# PLANNING COMMITTEE

**5. 22/1764/FUL - WORLD OF WATER, HEMPSTEAD ROAD, WATFORD, HERTFORDSHIRE, WD4 8QG**

Demolition of existing building and erection of retail food store, (Use Class E(a)), with associated access, parking and amenities.

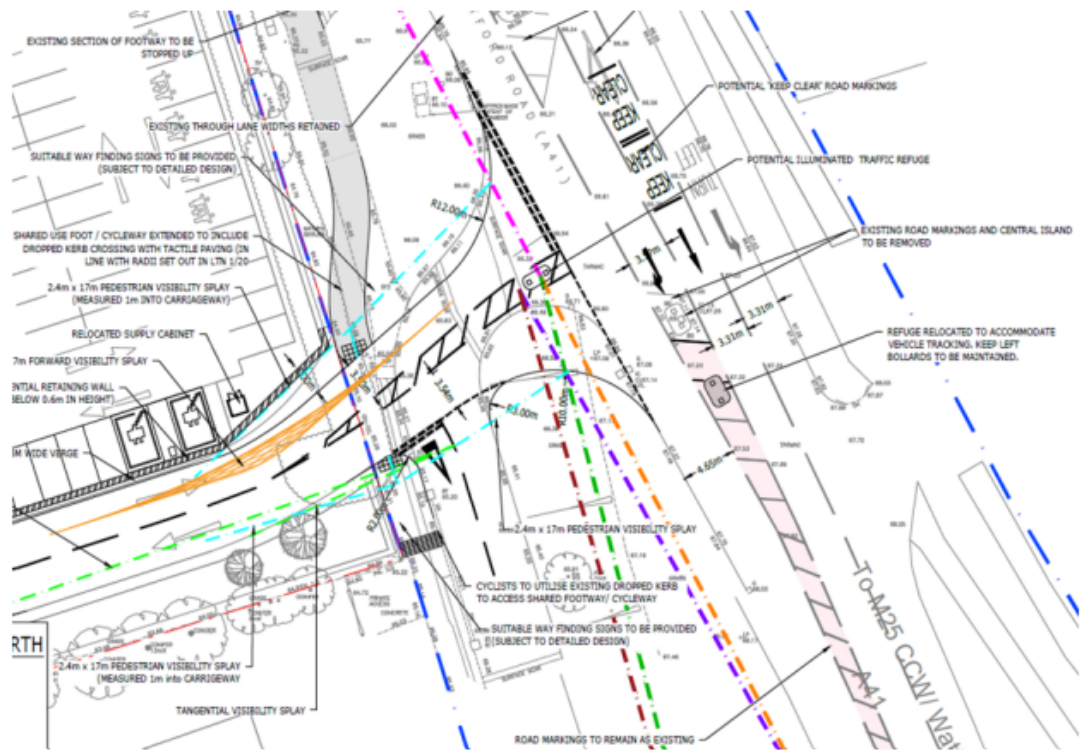
The above access presents a number of engineering challenges with the proposed foodstore usage to which the applicant's transport consultant has responded to, subsequent to comments made by the Highway Authority. This has included comments on visibility (both horizontal and vertical), vehicular access for large vehicles, geometry and turning into the site from both directions.

The Highway Authority has noted that safe and suitable access will need to be provided for goods vehicles servicing the proposed foodstore, that satisfactory visibility is ensured (in particular towards Hunton Bridge) and active travel is promoted.

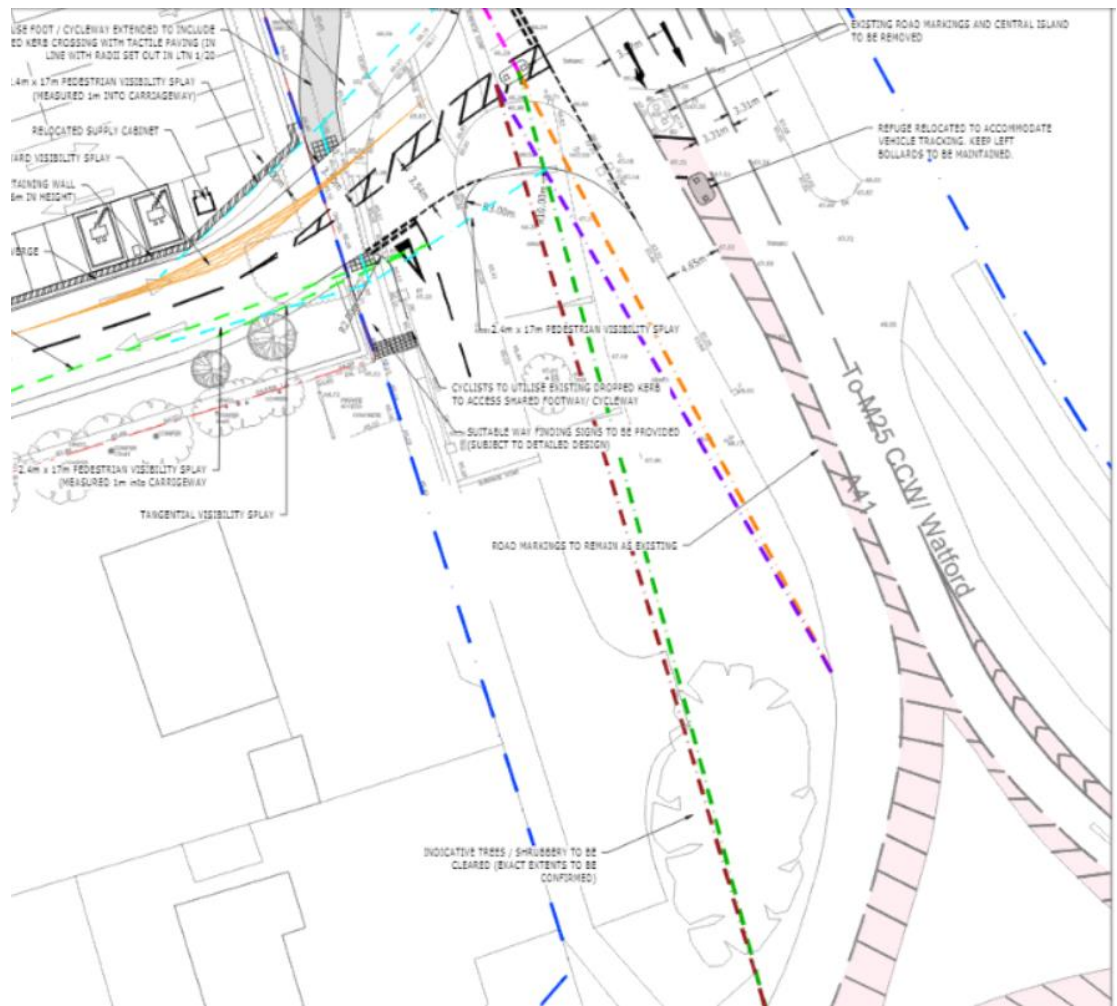
The Highway Authority note the substantial change to the existing access arrangement to the World of Water site and adjoining service road which will require a Section 278 and completion prior to the first use of the development. The Highway Authority note also the relocation of the existing uncontrolled pedestrian crossing and improvements to the walking and cycling routes in the immediate vicinity of the site.

In summary, the Highway Authority does not wish to restrict the grant of planning permission subject to the aforementioned planning conditions and Advisory Notes.

AD Scale	Date	Designed by
AS SHOWN	16.12.22	RDS
Drawn by	Checked by	Approved by
RDS	ATB	DM
Drawing Number	187011-001

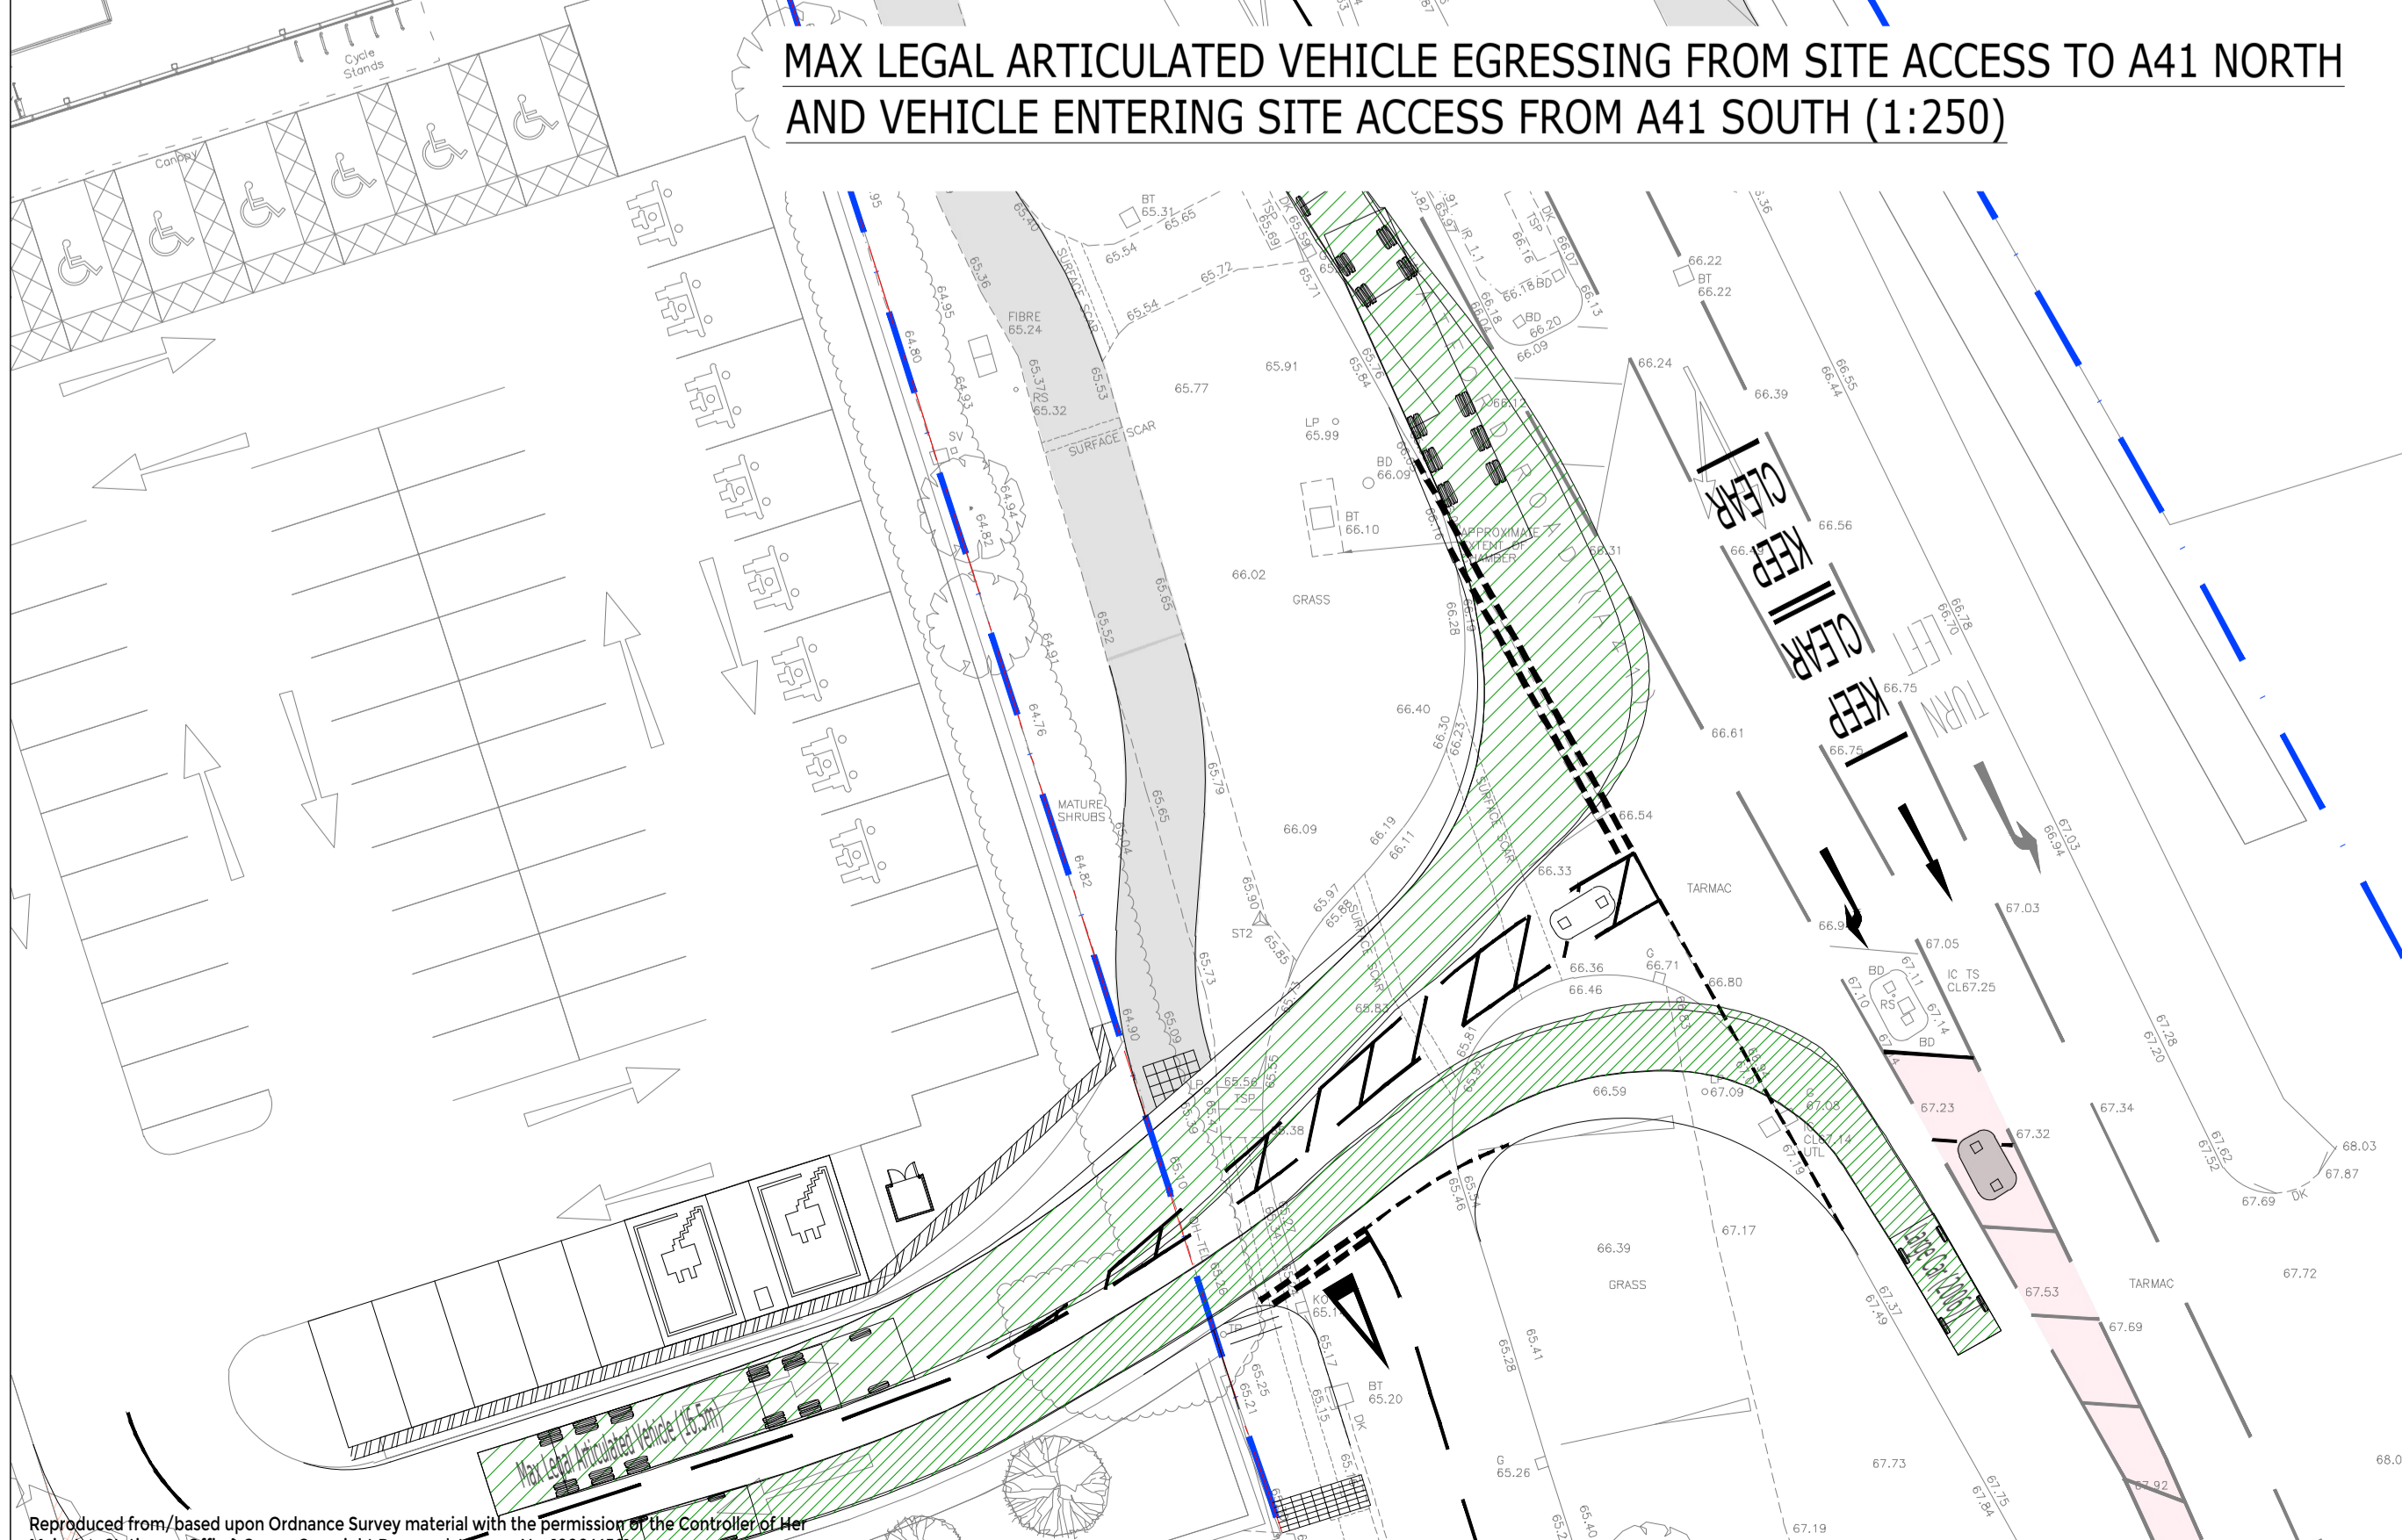
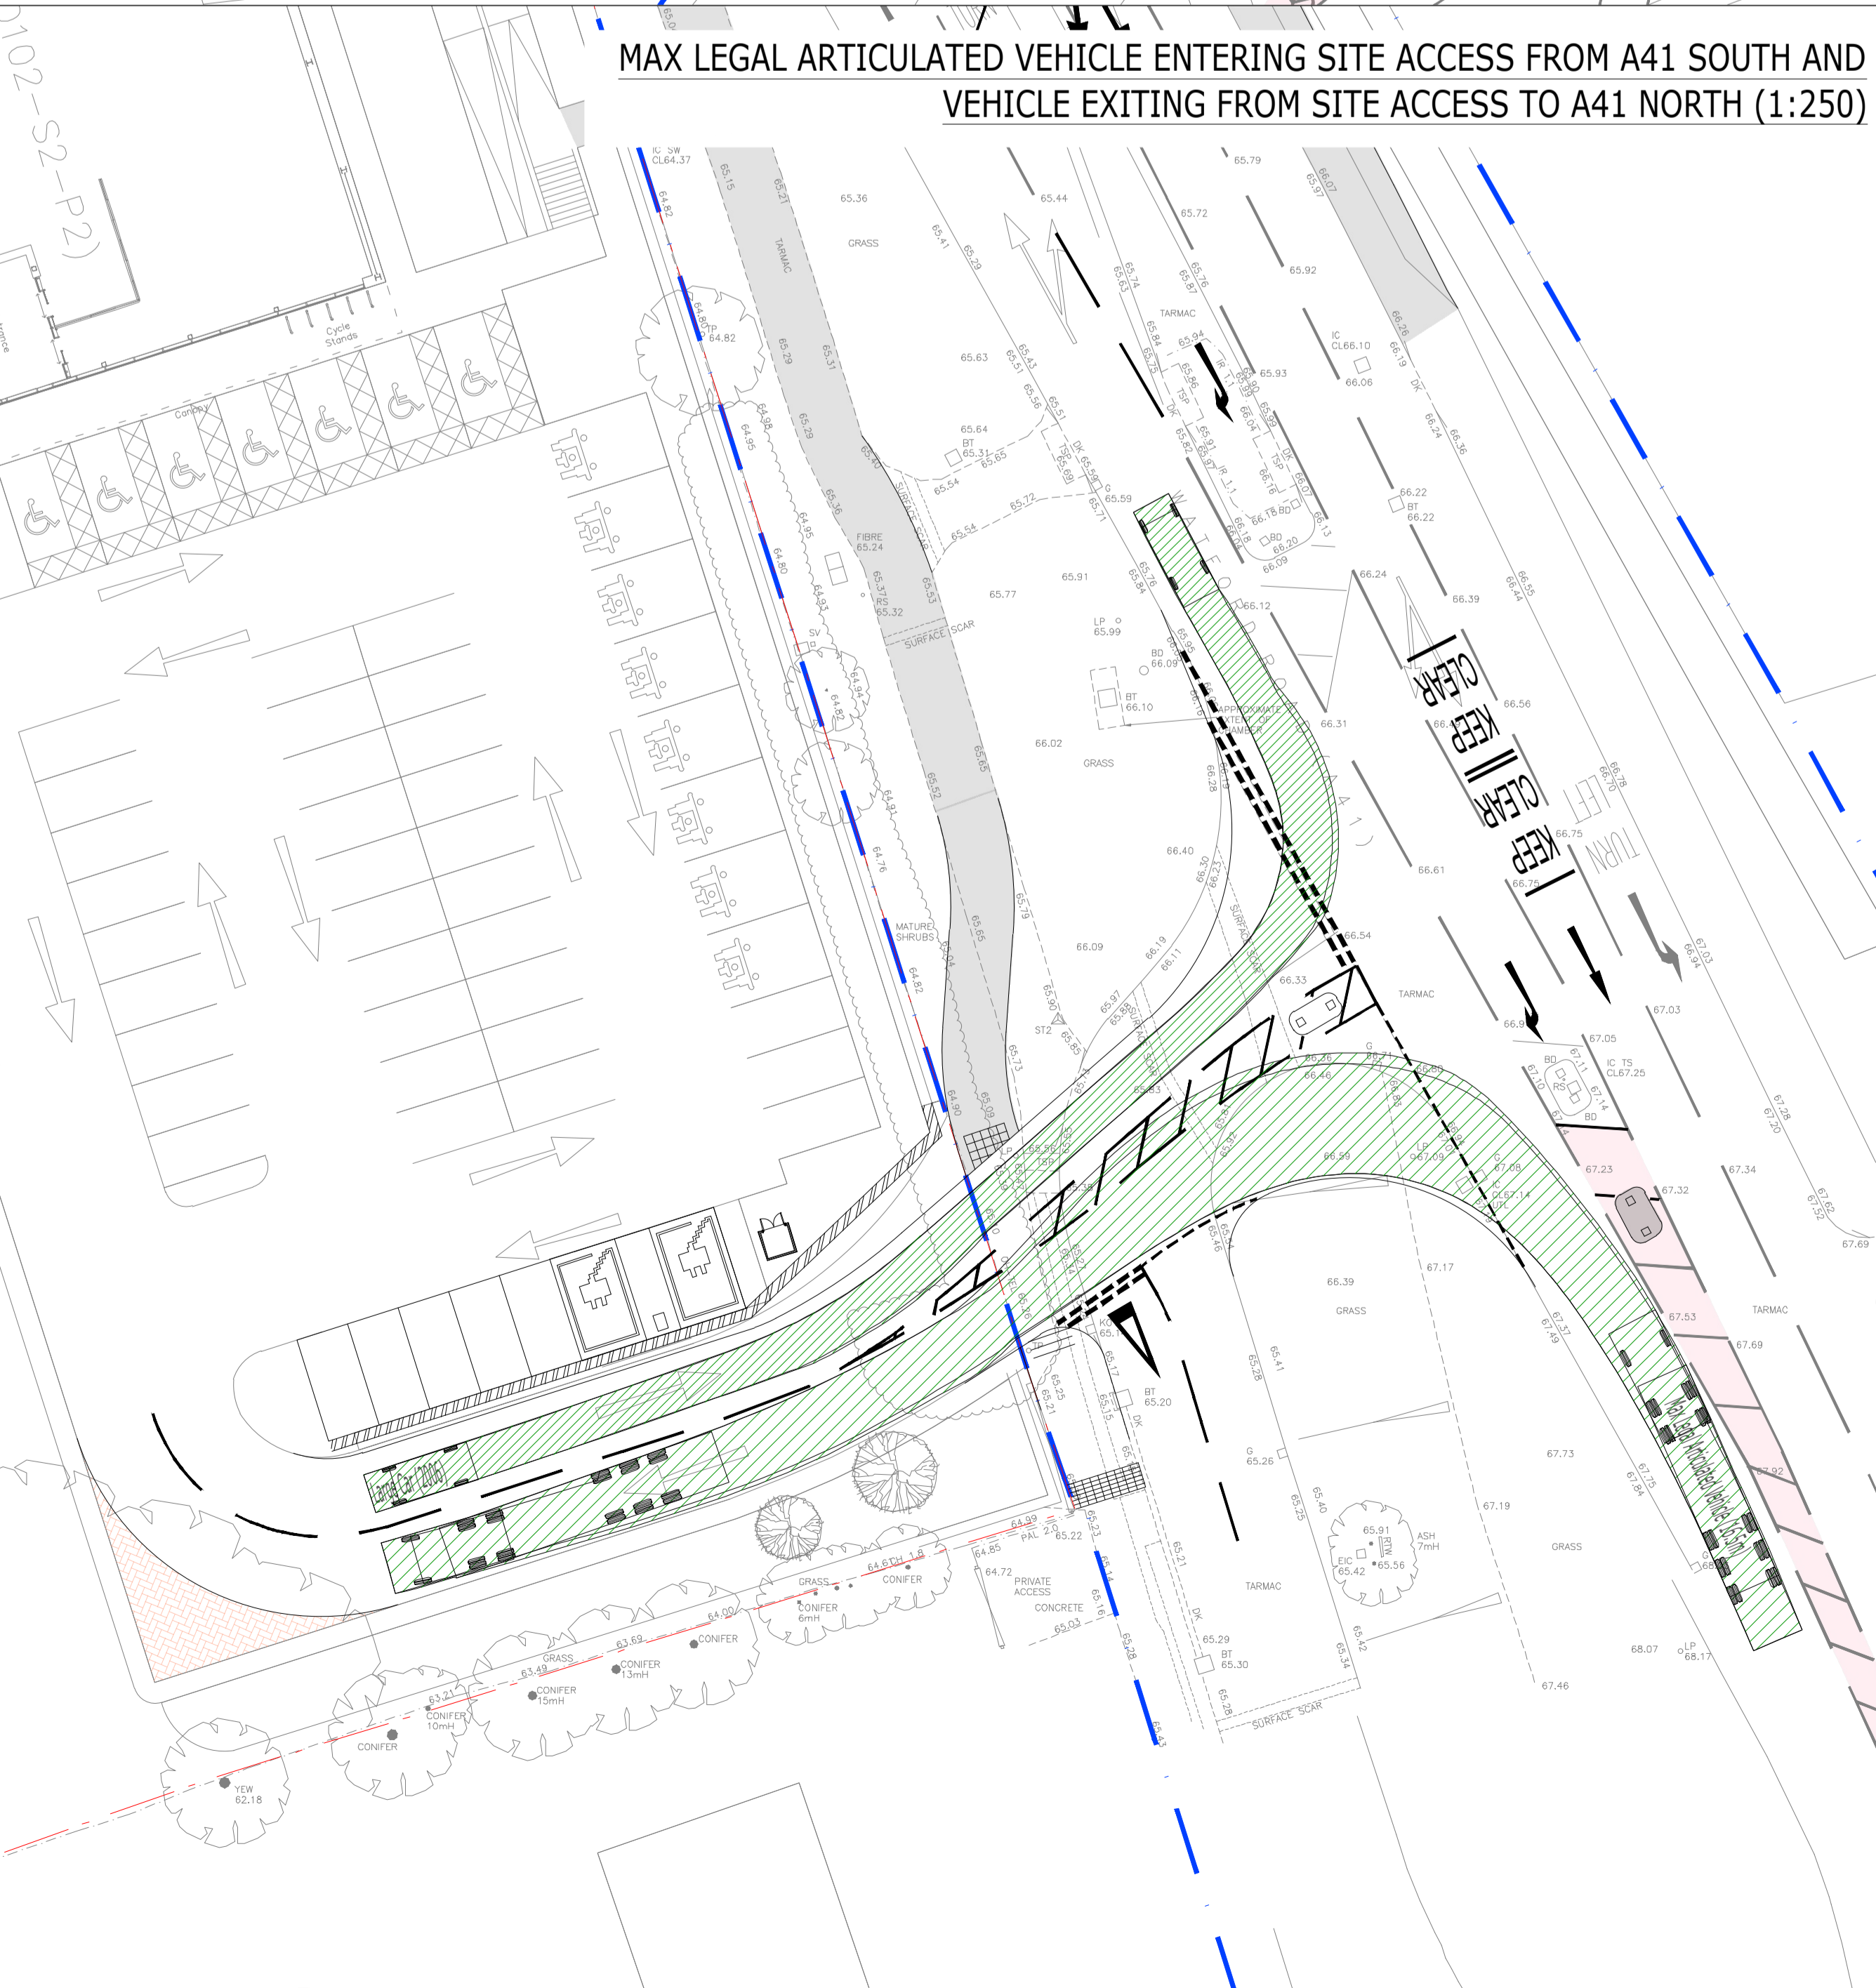
- 2.8 Notwithstanding the above, **ACE Drawing 187011-001J** has been updated to demonstrate how a 15m taper length could be provided (in line with CD 123 Table 5.22) for a 40mph speed limit, to alleviate the above concerns without significant impact on the proposed arrangement or requirement for additional modelling. The implementation of this increased direct taper would not have any significant impact on the proposed arrangement and should therefore not warrant refusal of the scheme. It is envisaged that this could be incorporated at detailed design stage, but the updated drawing included within this TTN should give confidence to the Committee that this can be delivered without significant impact on the overall operation of the junction.

2.62 In light of the above, **ACE Drawing 187011-001J** has been updated to demonstrate how a longer stagger of 1.8m on the island could be provided to ensure that cyclists could safely manoeuvre through the stagger. At this stage of the process, it is envisaged that this would be implemented and investigated further at detailed design stage. Though at this stage, should alleviate the concerns raised by the independent highways review by demonstrating that this minor amendment could be implemented if deemed as a requirement.
